**22-COA-0112**  
**141 Pope St.**

**Clifton Architectural Review Committee**  
**Public Hearing**

**Bradley Fister, Historic Preservation Specialist**  
**June 3, 2022**

# 9600 Series

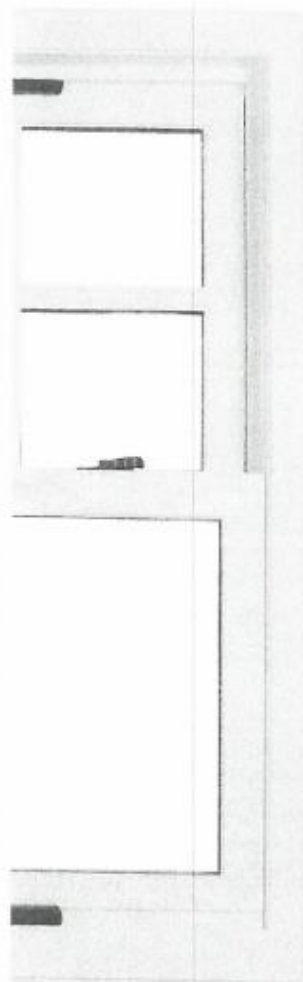
On the basis of the information furnished by the applicant, staff recommends a Certificate of Appropriateness be **denied** as the proposed vinyl replacement windows do not meet the design guidelines.

However, if the ARC determines that the proposed vinyl is an appropriate material, or if the applicant is willing to change replacement window material, then staff recommends a Certificate of Appropriateness be **approved with the following conditions**:

1. The three after-the-fact replacement windows shall be replaced with one-over-one replacement windows that closely match the dimensions of the historic wood windows.
2. The replacement windows for the two front facing second-story windows shall be one-over-one and shall closely match the dimensions of the historic wood windows..
3. All glass shall be clear and non-reflective.
4. The applicant shall not wrap the window trim or sills with vinyl or aluminum.
5. The applicant shall take precautions to preserve any existing wood elements to be reapplied to the building and shall submit photographs of all elements proposed to be reconstructed.
6. The applicant shall take appropriate precautions with the handling of potential lead paint.
